**A66 Northern Trans-Pennine project
TR010062**

**8.1 Change Application –
Application Report**

24 March 2023

Planning Inspectorate Scheme Reference	TR010062
Application Document Reference	8.1
Author:	A66 Northern Trans-Pennine project, Project Team, National Highways

Figure DC-22(a) Schematic of Proposed Change (Before & After)

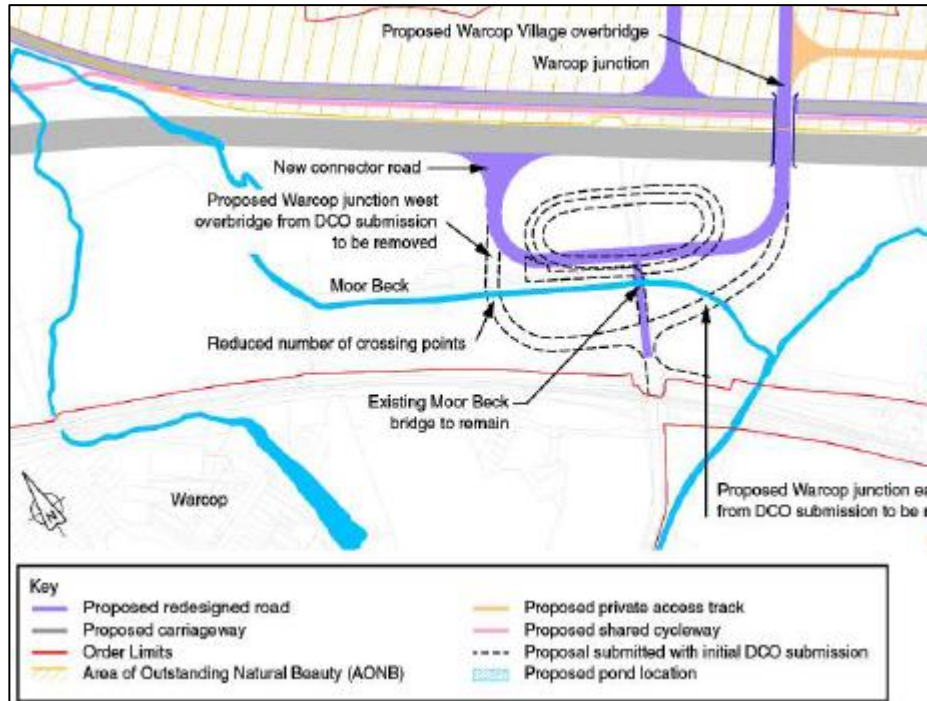
- 3.22.1. **Background to the change:** At Warcop the current DCO design includes an overbridge which will give access to the new A66 in both directions for people travelling to and from the village. The westbound junction and loop, on the south side of the A66, requires crossing Moor Beck in two locations.
- 3.22.2. **Description of the change:** The change seeks to introduce greater flexibility in the LoDs in this location, to allow the loop to be moved closer to the new A66, and north of Moor Beck compressing the junction (see Figure DC-22(a)).

Figure DC-23(c) Extract from Works Plans (After)

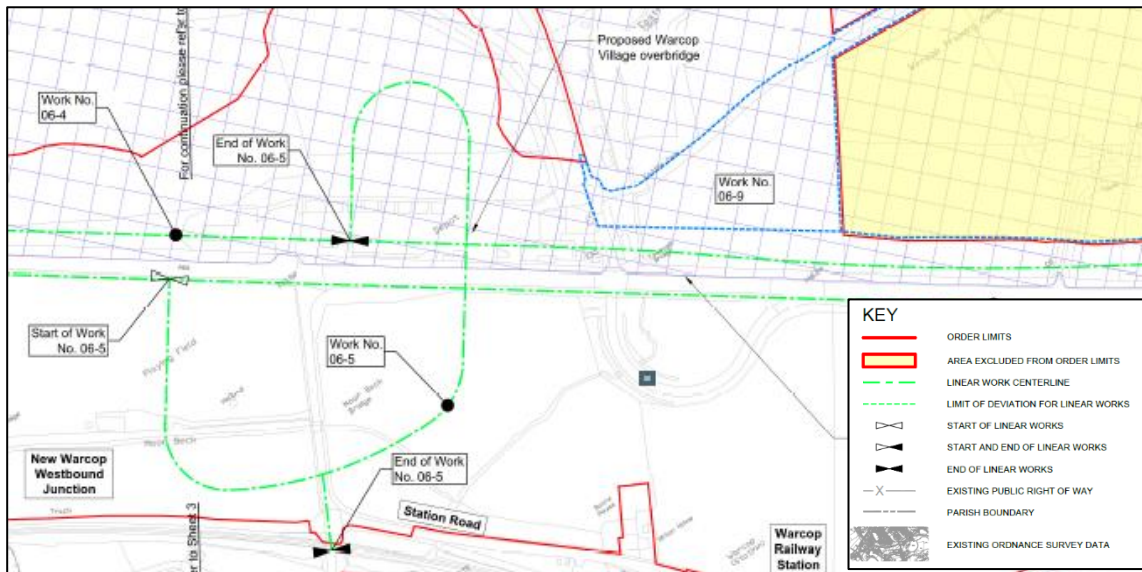
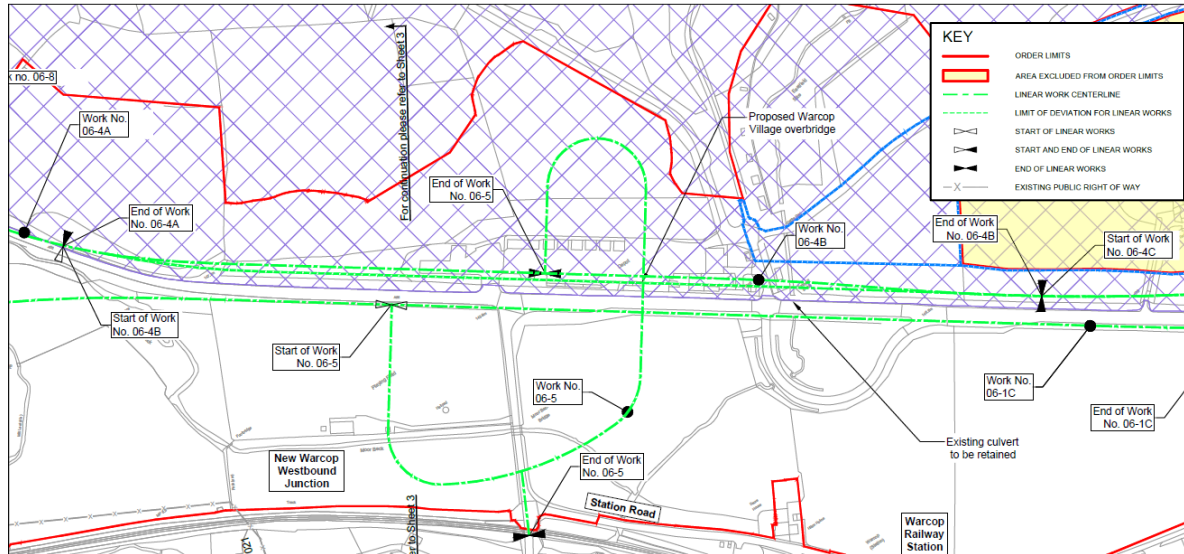
under proposed change DC-24. This proposed change will require amendments to the LoDs associated with Work No. 06-4B (refer to Figures DC-23(a) and DC-23(b)).

Figure DC-25(c) Extract from Classification of Roads Plans (Before)

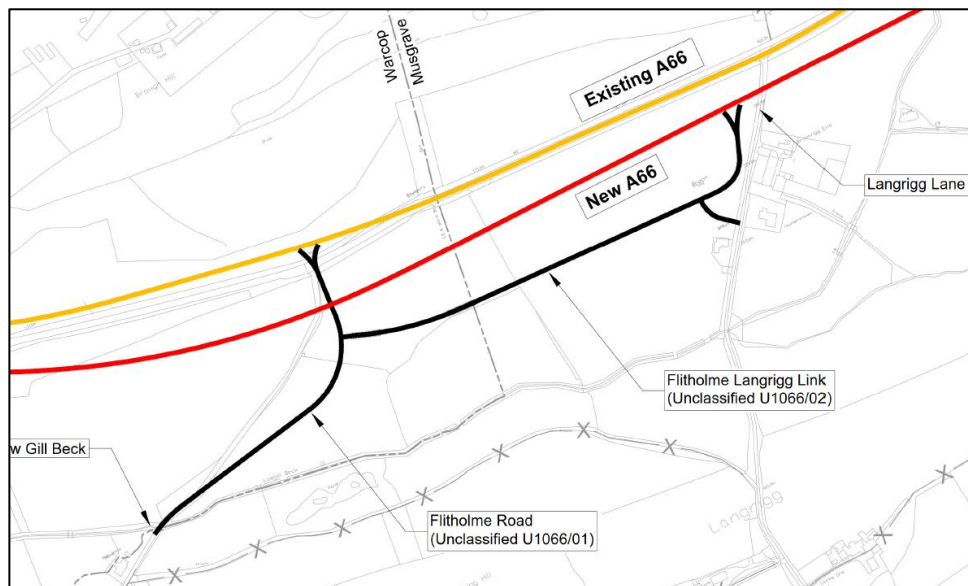
- 3.25.6. This change would require amendment to the extent of the classification of the U1066-01 as shown on the Classification of Road Plans. Refer to Figure DC-25(d).

Figure DC-26(b) Extract from General Arrangement Drawing (After)

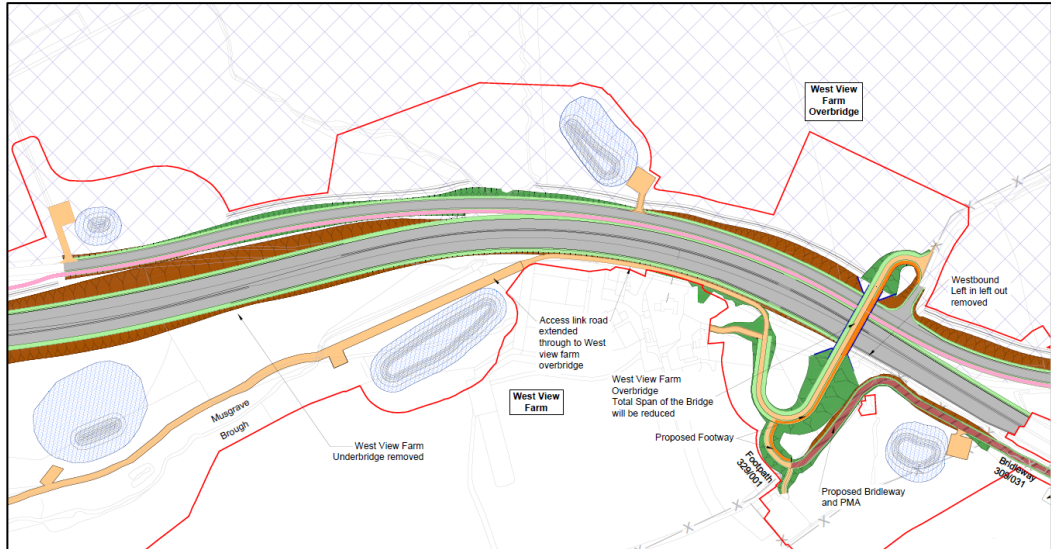
- 3.26.6. **Alignment/ Design Speed/ Speed Limit:** There is no impact to the proposed alignment, road classification, design speed or speed limit as result of this change.
- 3.26.7. **Public Rights of Way/Access Tracks:** The PMA servicing West View Farm (Reference 42 on the ROW & Access Plan) will be facilitated by a new access track adjacent to the northern side of the A66 mainline (Refer to Figure DC-26(d)) within the DCO Order limits. There are no other amendments to any other Public Rights of Way or access tracks as a result of this change.

Figure DC-28(b) Extract from General Arrangement Plans (After)

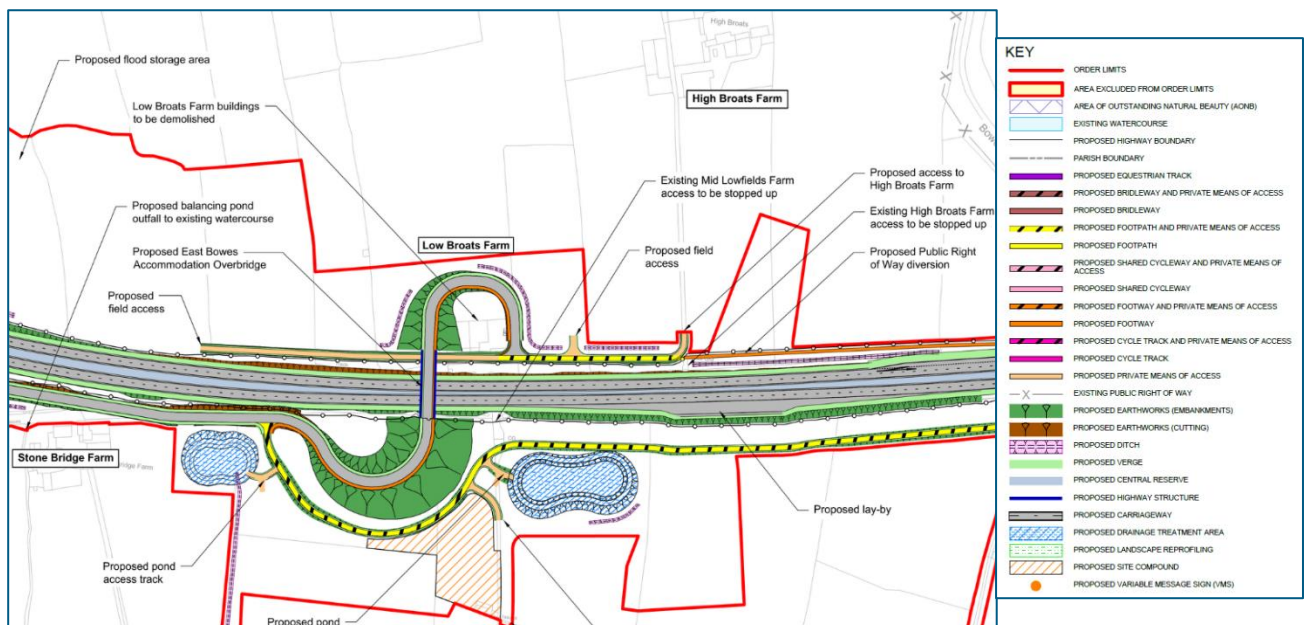
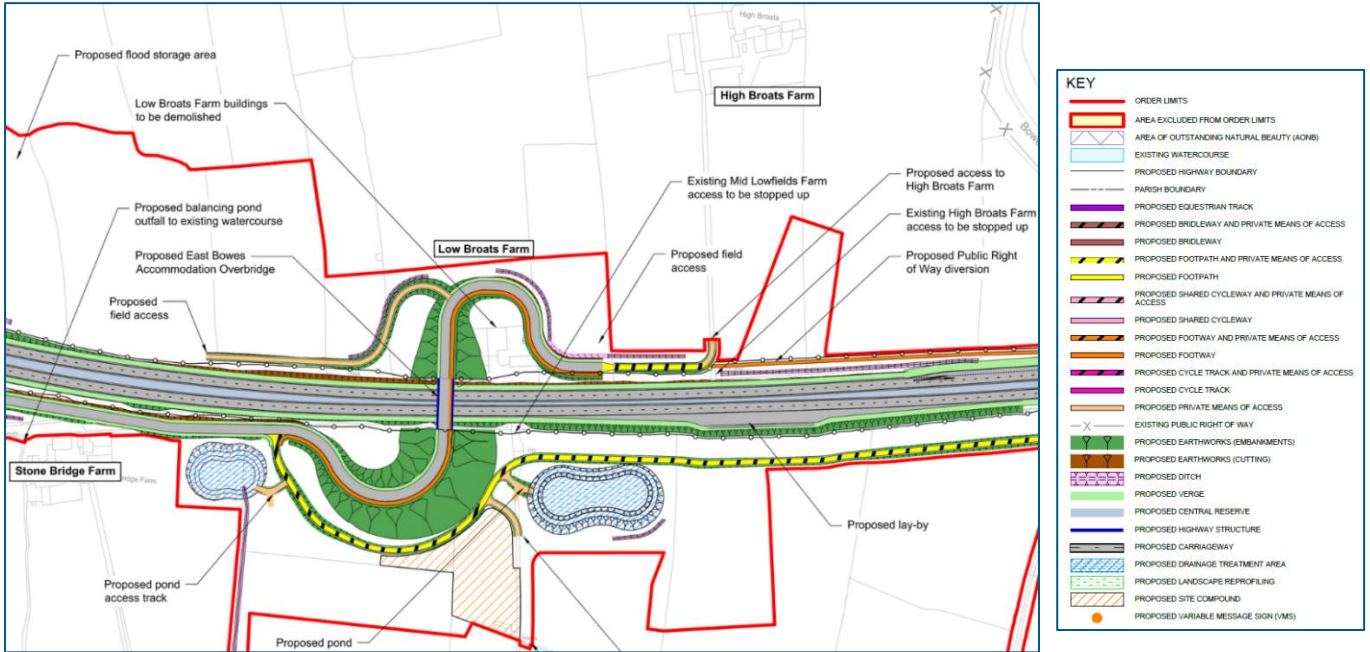
- 3.28.1. **Background to the change:** The current design for the East of Bowes provides a Private Means of Access north of the A66, accessed via a new link from The Street. A track runs parallel to the A66 mainline and passes under the back span of East Bowes Accommodation Overbridge as shown in Figure DC-28(a).

Deviation to reduce the span of the new overbridge by approximately 20m and realign the PMA as shown in Figure DC-28(b).

Figure DC-28(d) Extract from Works Plans (After)

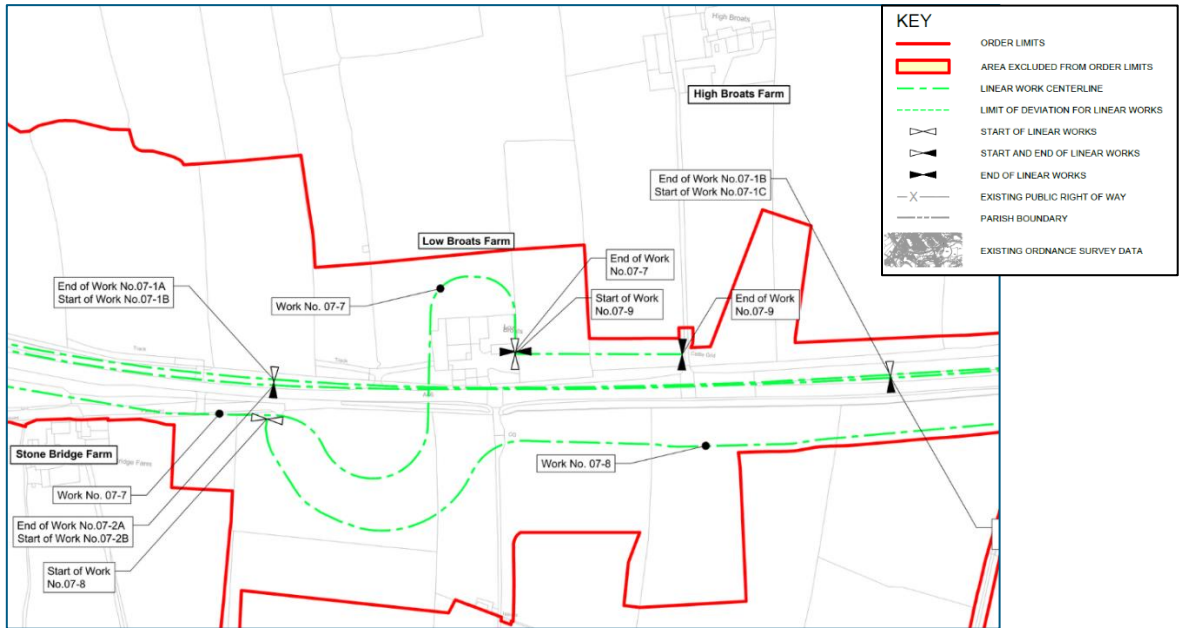
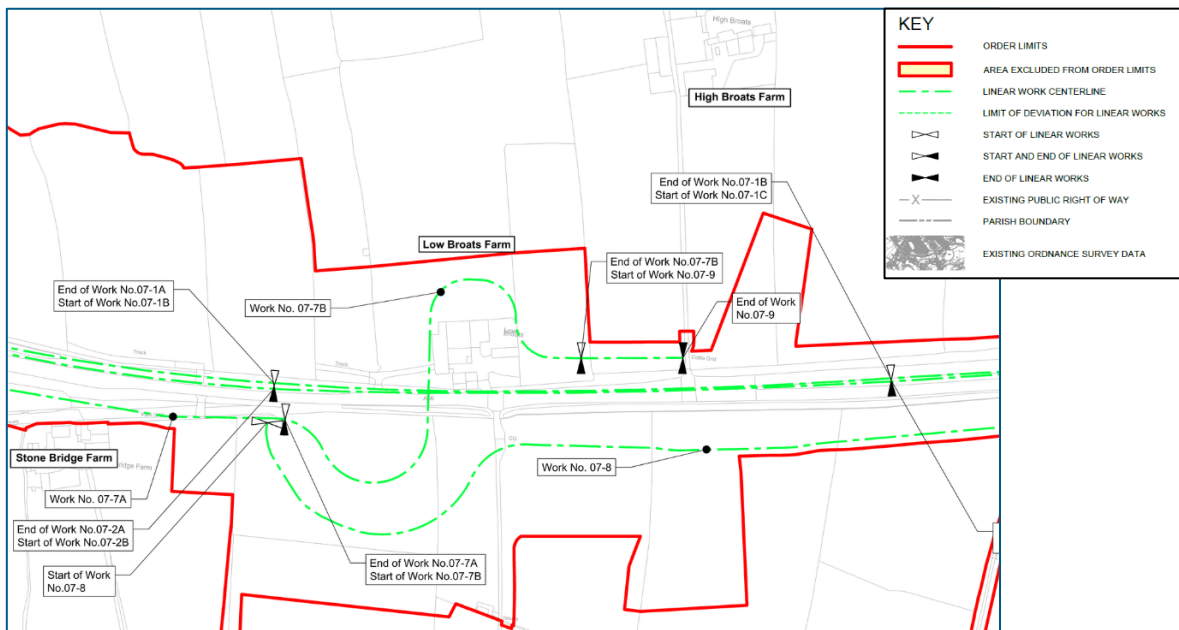
3.28.13. As outlined in Table DC-28(a), it is proposed that Work No. 07-7 is split into Work No. 07-7A and Work No. 07-7B (at Ch0+300m) and that new LoDs apply from Ch0+300m to the end of the alignment. The horizontal LoDs would not change (3m variance on the centreline) but the vertical LoDs would change to 2m upward and 2m downward, for the new numbered work – 07-7B. Refer to Table DC-28(a) and Figures DC-28(c) and (d).

Figure DC-30(b) Extract from General Arrangement Plans (After)

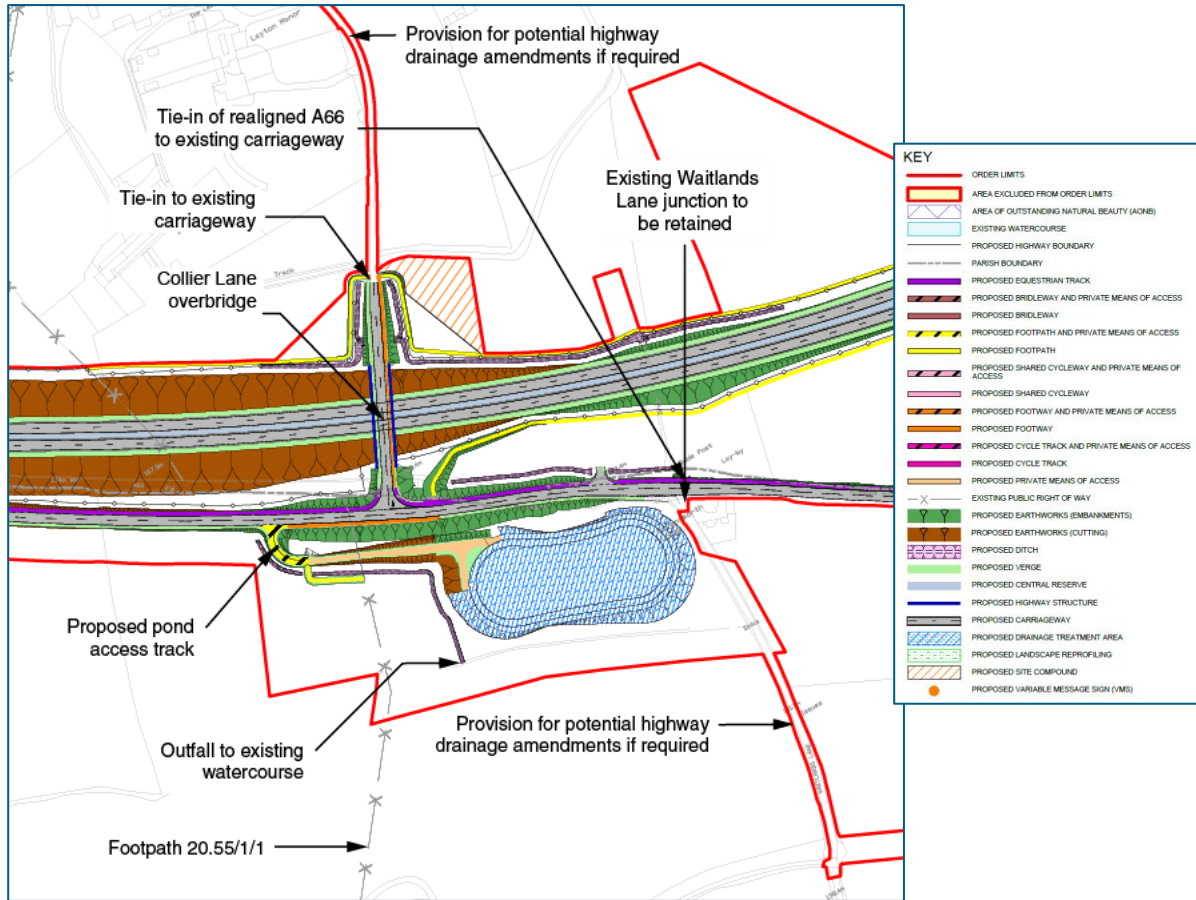
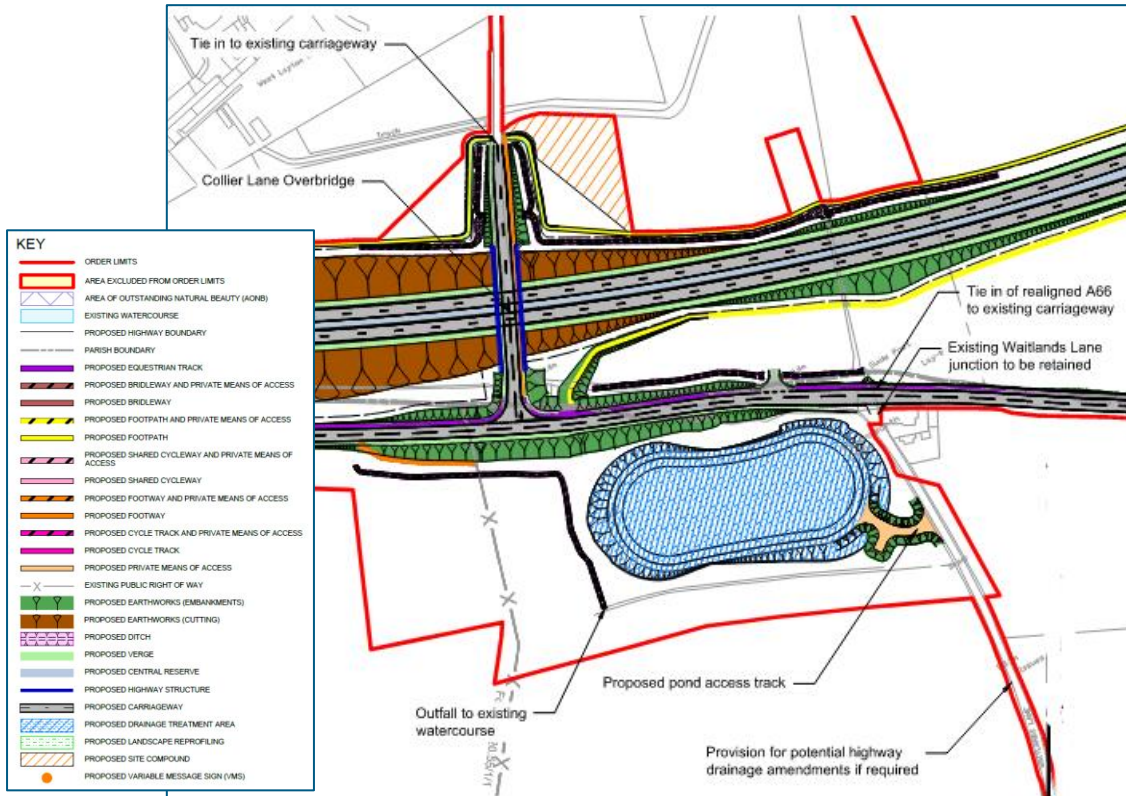
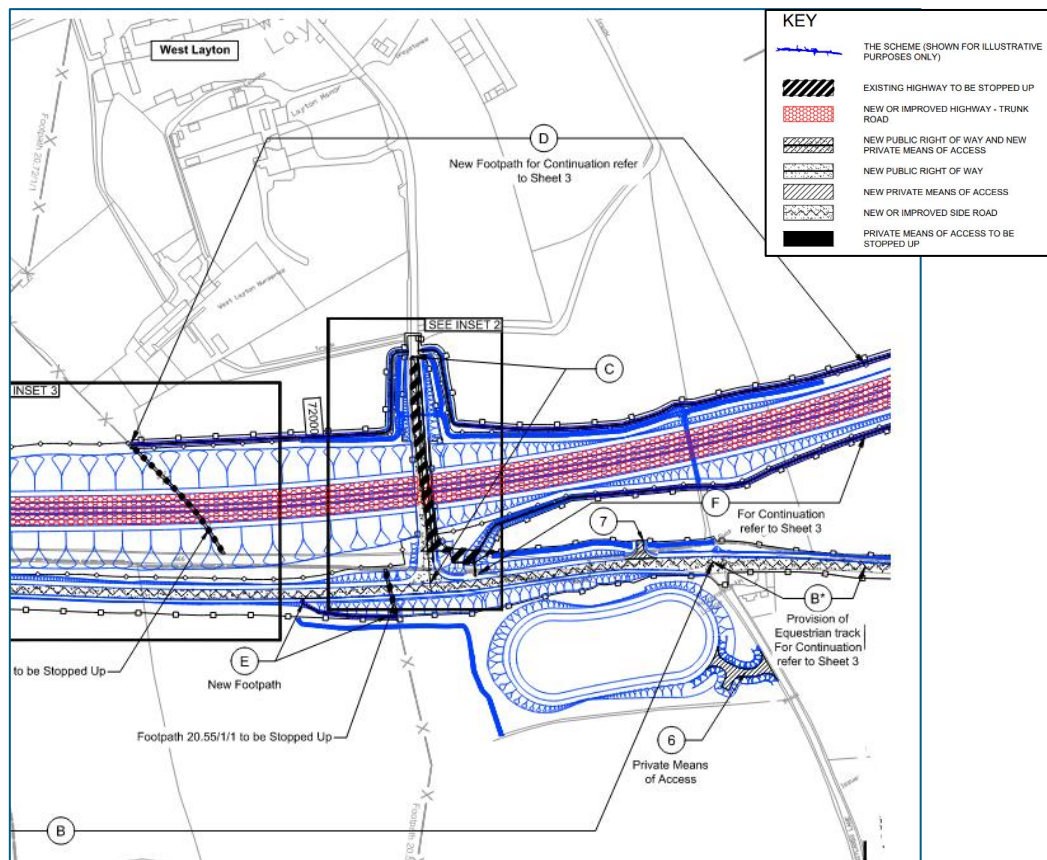
- 3.30.1. **Background to the change:** The current design for the DCO application included a balancing pond close to Waitlands Lane on the south side of the A66, north of Ravensworth. This balancing pond has a maintenance access track running west to join the de-trunked section of the A66 which is parallel to the south of the new A66 alignment in this location.
- 3.30.2. Footpath number 20.55/1/1 is diverted around the access track to meet with the de-trunked A66. Refer to Figure DC-30(a).

3.30.3. **Description of the change:** The change relates to moving the maintenance access to the balancing pond from the west to the east to connect to Waitlands Lane. This would reduce the extent of realignment of the existing footpath, which can stay on its existing alignment up to the proposed highway boundary. Once inside the highway boundary, a small ramp and / or short realignment along the de-trunked A66 embankment will be required to bring it up to the new level of the de-trunked A66 in compliance with relevant DDA and LTN/120 standards. Refer to Figure DC-30(b) and (c).
